APPROVED MINUTES

June 20, 2013 Standards Committee Meeting **(Changes by the Action of the Committee on September 19, 2013 meeting highlighted yellow)**

RE: Minutes from the June 20, 2013 Standards Committee Meeting

605-CCSJ-01 CONCRETE AND ASPHALT CURBS AND SAWED JOINTS (WITH MARKUPS)

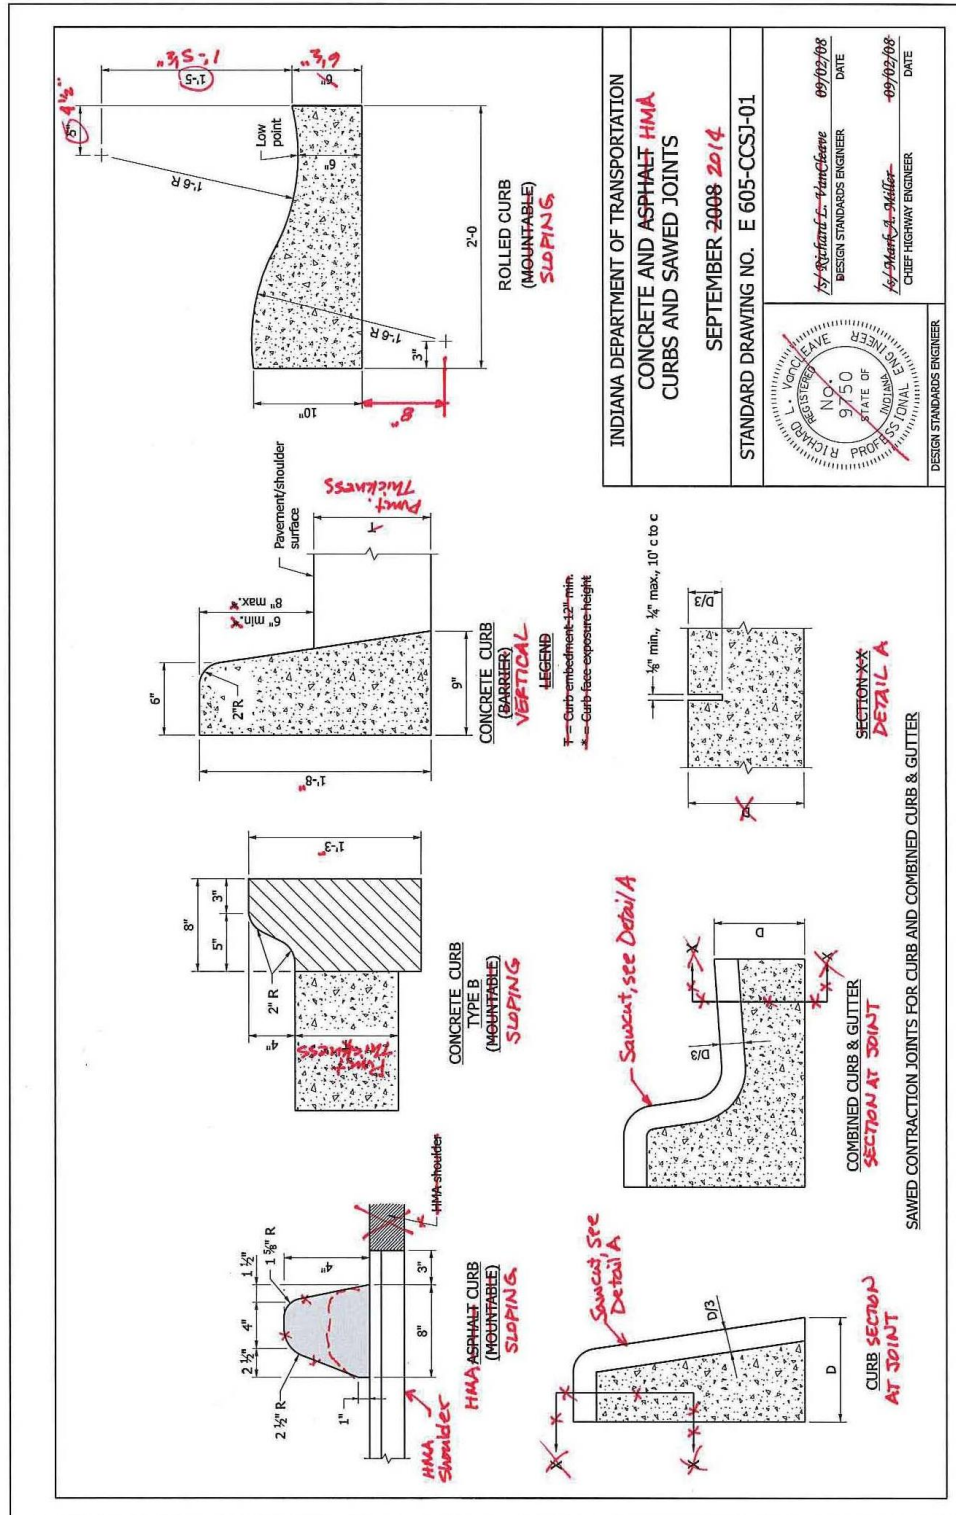
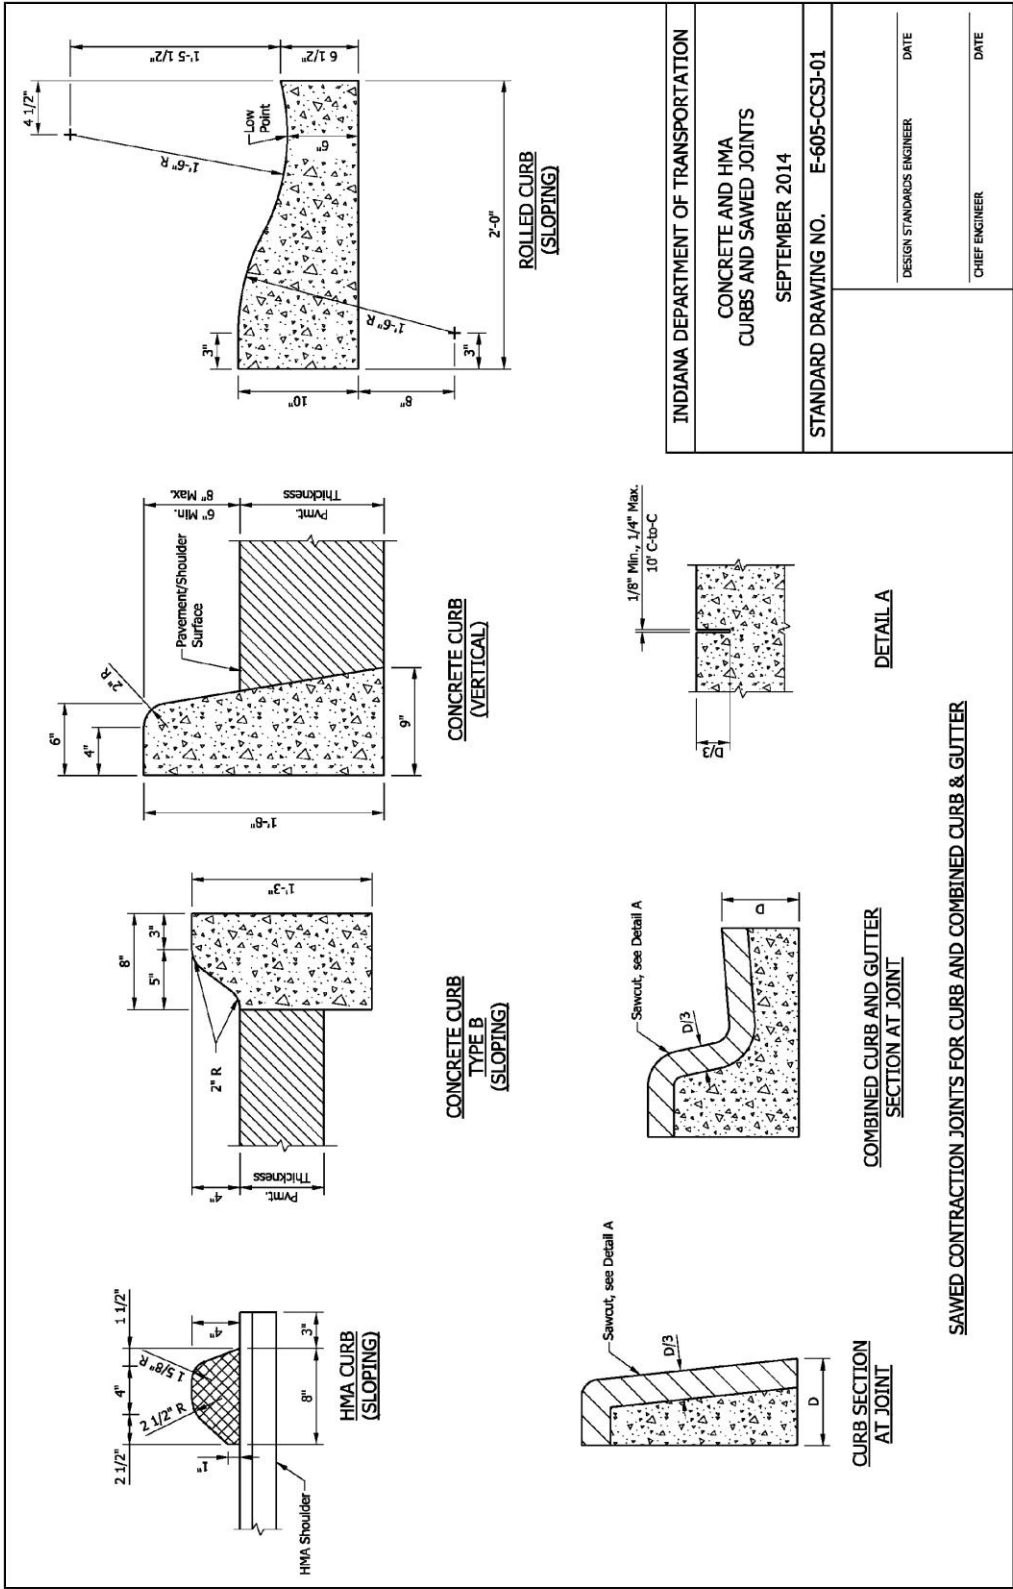
605-CCSJ-01: Corrected drawing of HMA Curb to more accurately reflect 4" height, updated terminology to agree with current practice and pay items ("Mountable" changed to "Sloping", "Barrier" changed to "Vertical", "Asphalt" changed to "HMA"), reorganized sections at joint, updated drawing format in general.

Update drawing format, text style, dimension style.

706-MSRW-01 RAILING TYPE FC AND MOMENT SLAB ASIDE MSE WALL - PCCP (WITH MARKUPS)

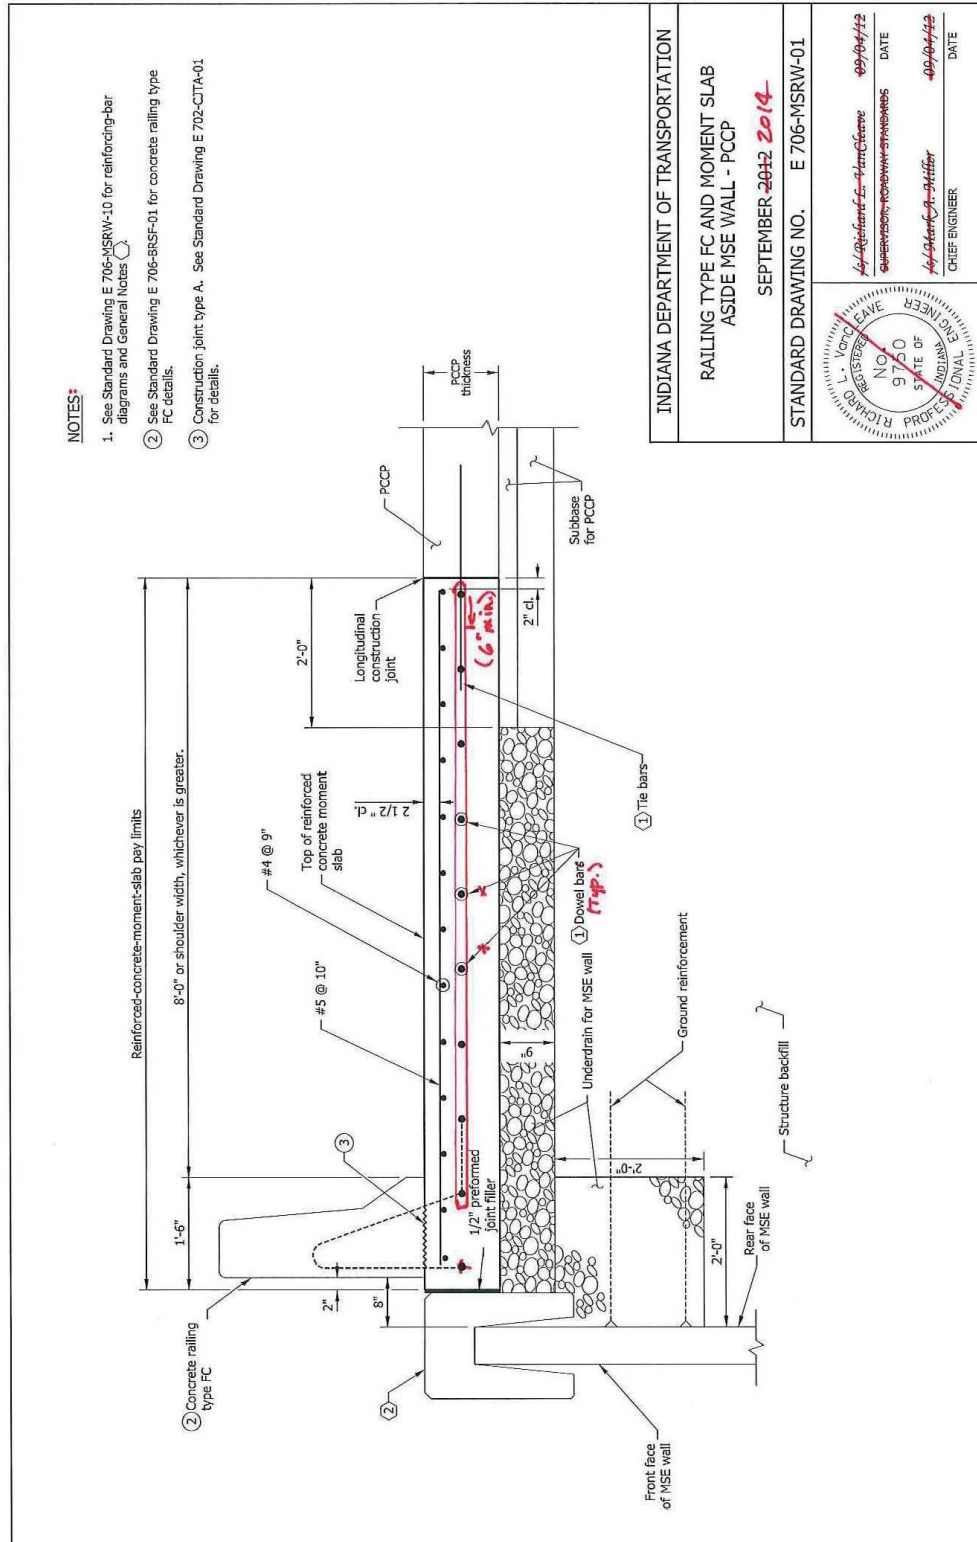
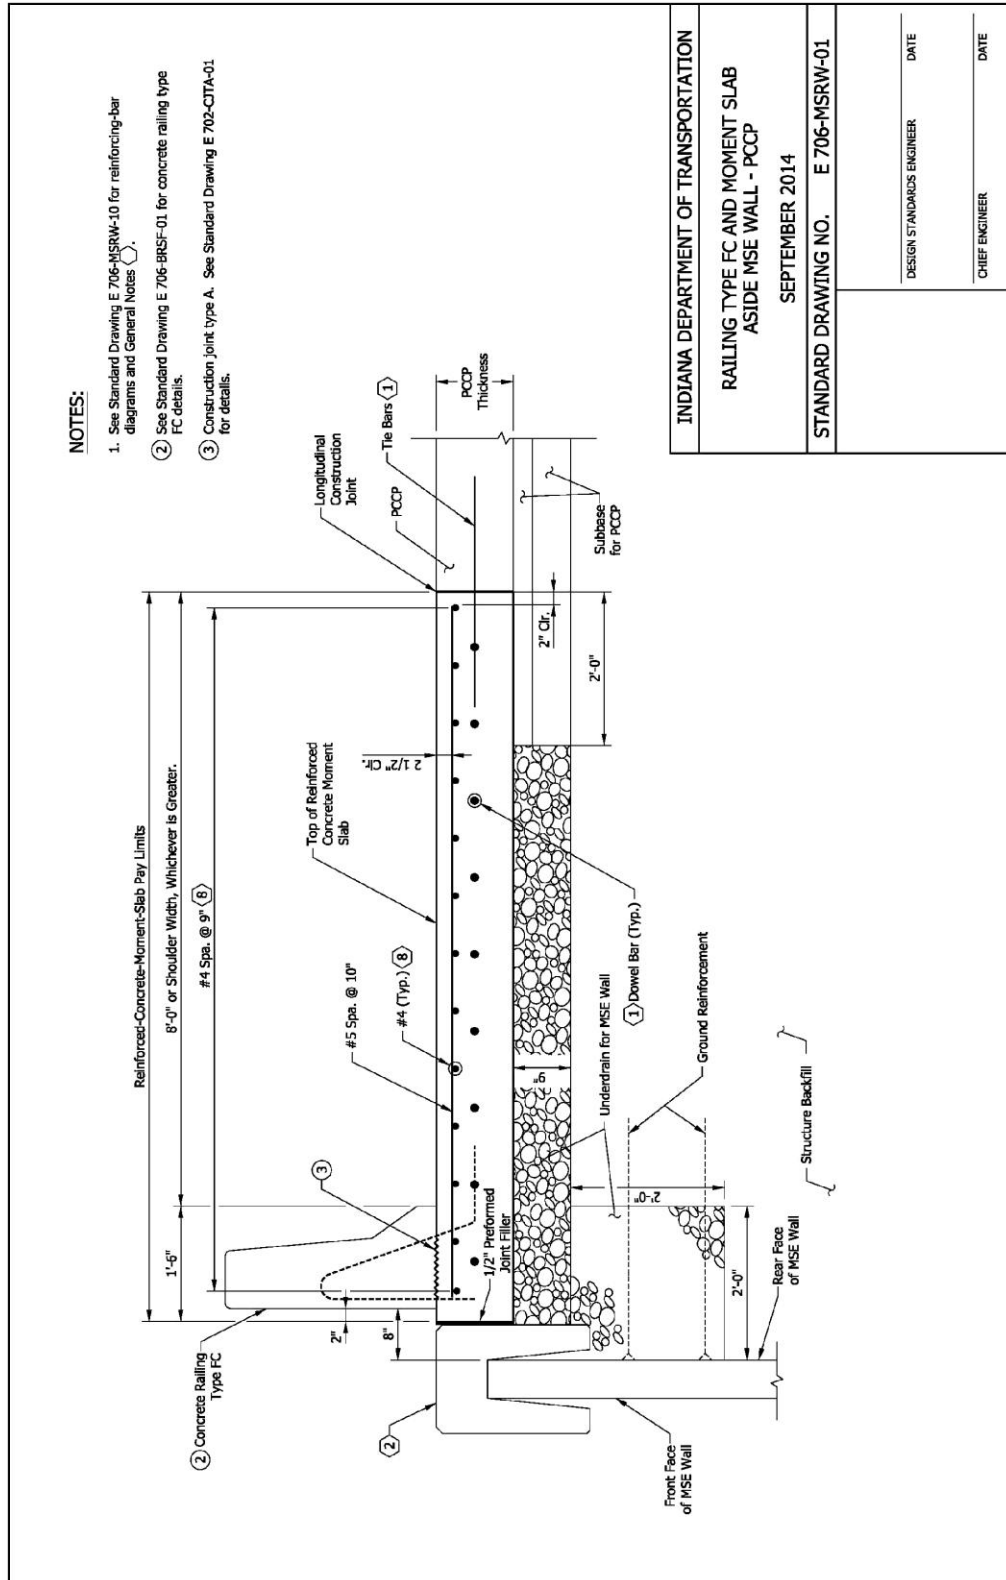
706-MSRW-01 thru -10: Relocated dowel bars in moment slab to reflect 6" minimum clearance from edge of pavement, updated drawing format in general.

Ms. Phillips then explained the revisions made on the accompanying drawings. Further discussion ensued concerning the revisions made to the moment slab drawings. Minor edits were suggested for the open grade layer under the moment slab (drawings 706-MSRW-01 thru -08) with regards to the underdrains. Ms. Phillips said she will make those editorial revisions. Mr. Miller asked if direction will be needed for each contract, and Ms. Phillips agreed. Ms. Phillips said she will withdraw the moment slab series from this proposal and bring it back at a later date.

706-TTX-01 CONCRETE BRIDGE RAILING TRANSITION, TTX (REVISED DRAFT)

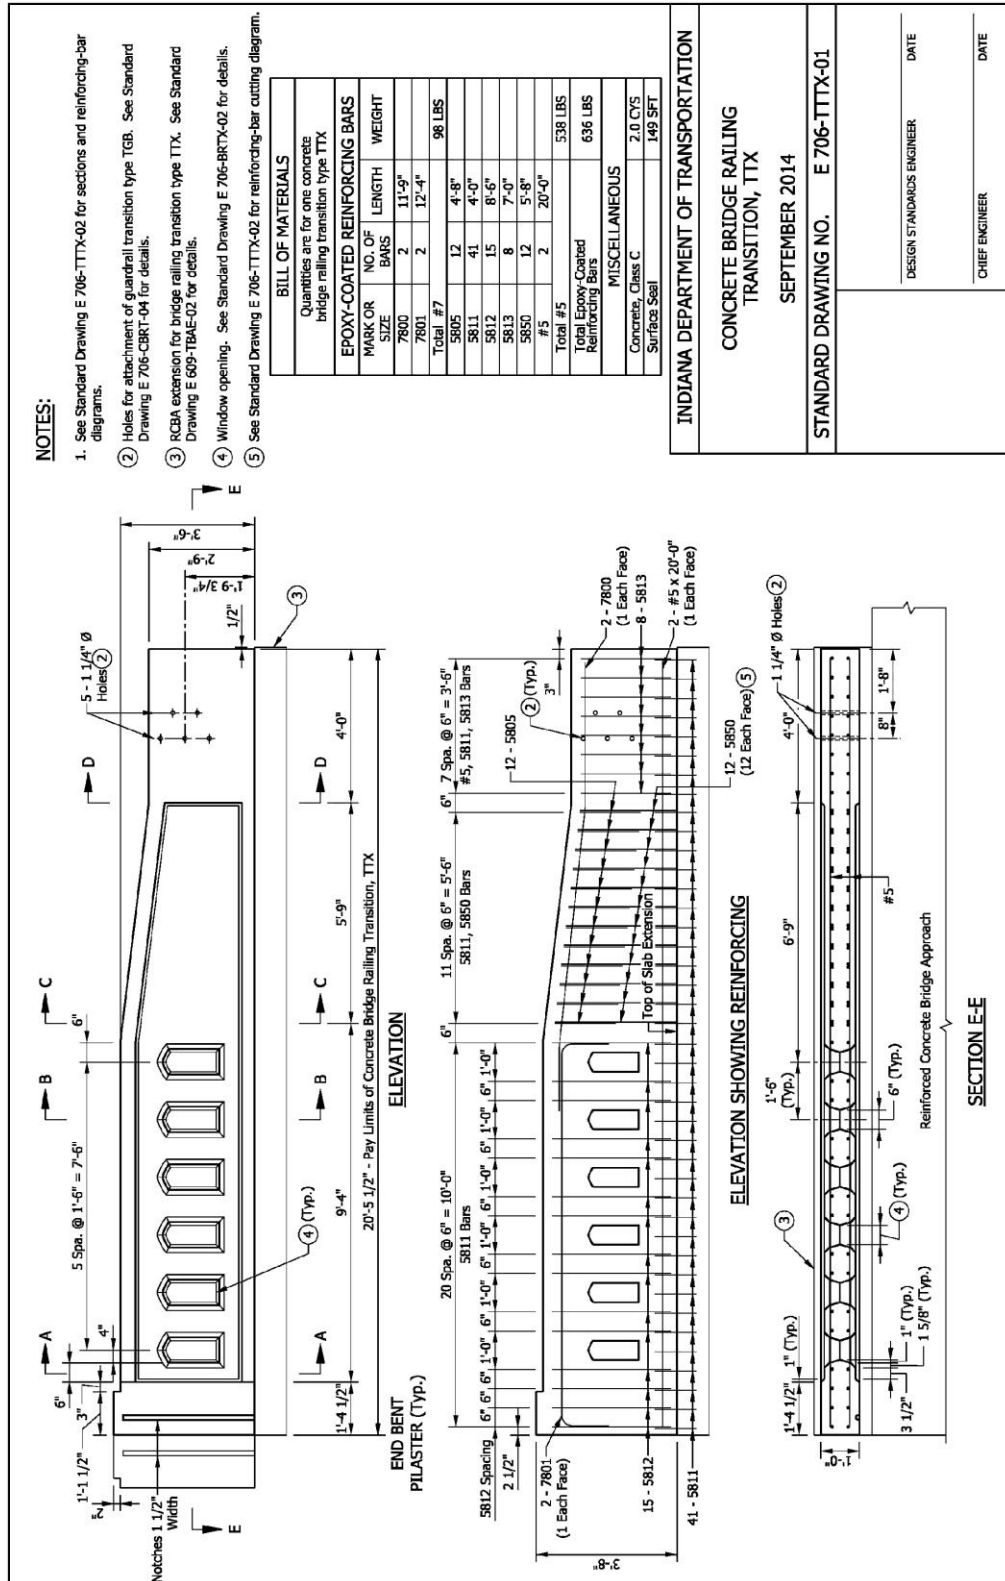
706-TTXX-01 and -02: Corrected spacing description in Elevation, updated terminology to agree with current practice and pay items ("Steel" changed to "Bars"), updated drawing format in general.

802-SCSB-08 SIGN CANTILEVER STRUCTURE BUTTERFLY FOUNDATION AT 33"
CONCRETE BARRIER (REVISED DRAFT)

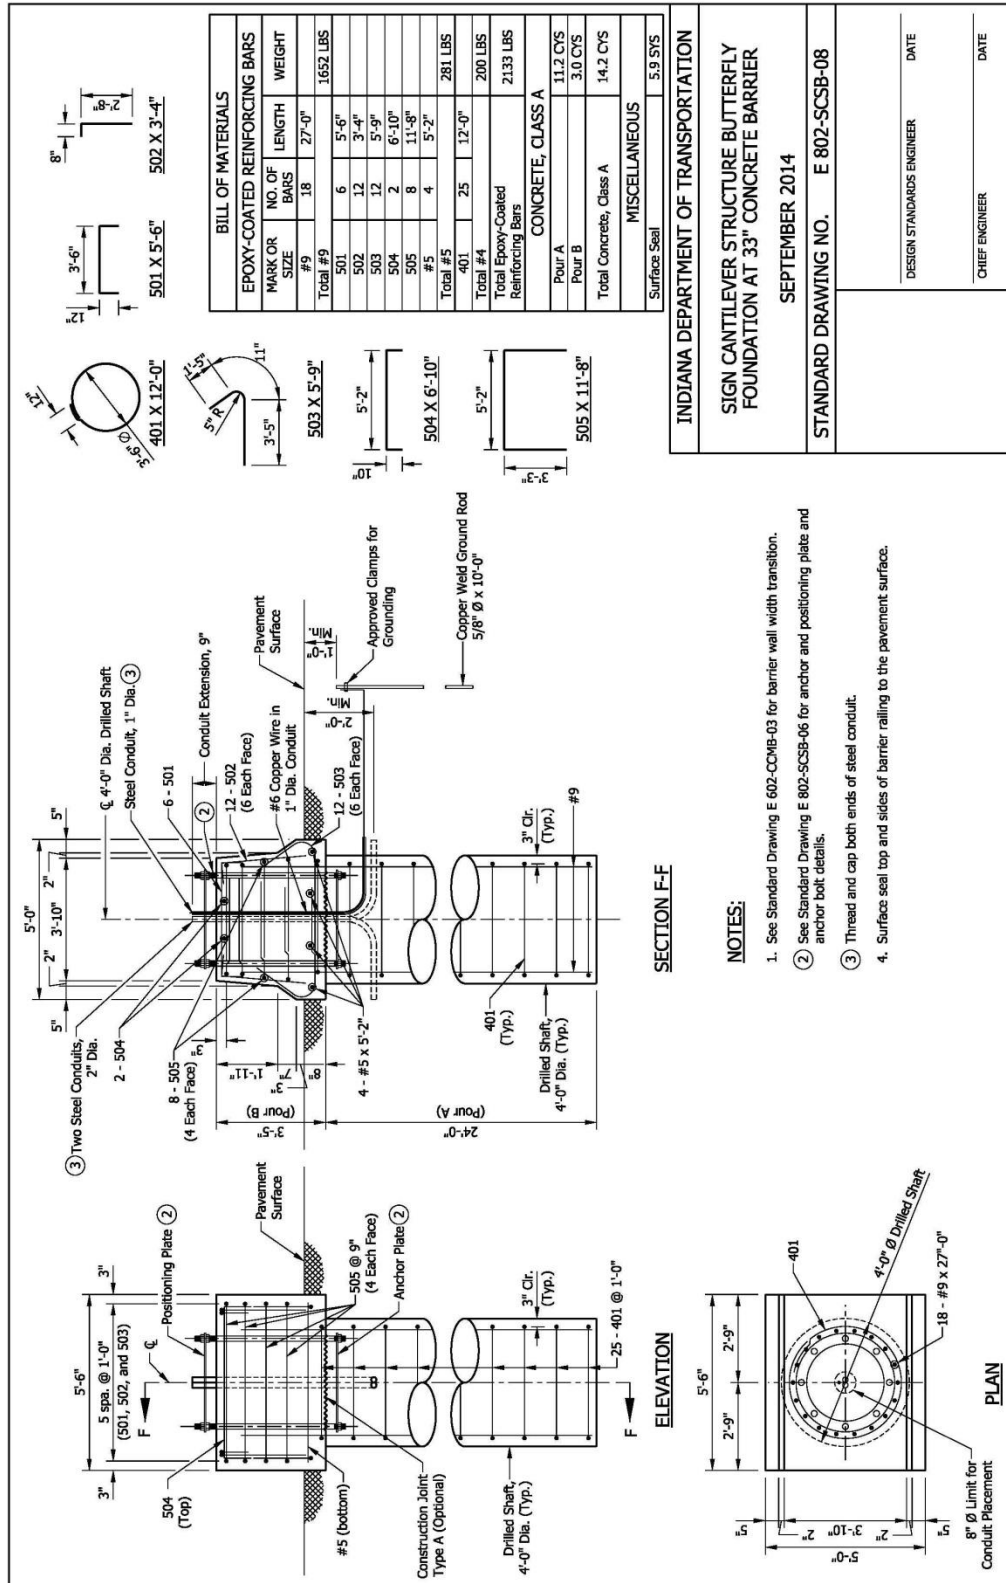
Mr. Hanza asked to make a change to Note 1 on drawing 802-SCSB-09 concerning the 28° friction angle. Mr. Hanza would like to change it to 30°. Ms. Phillips confirmed that the 30° is consistent with the other foundation designs, as is shown on drawing 802-SCSB-08. Following the meeting it was decided to remove Note 1 on sheets 8 and 9 of this set of drawings to be consistent with sign and signal traffic structures (sign cantilever, tri-chord, DMS, etc.) standard drawings recently approved. The remaining notes were renumbered accordingly. The revised drafts of these sheets are shown in these minutes.
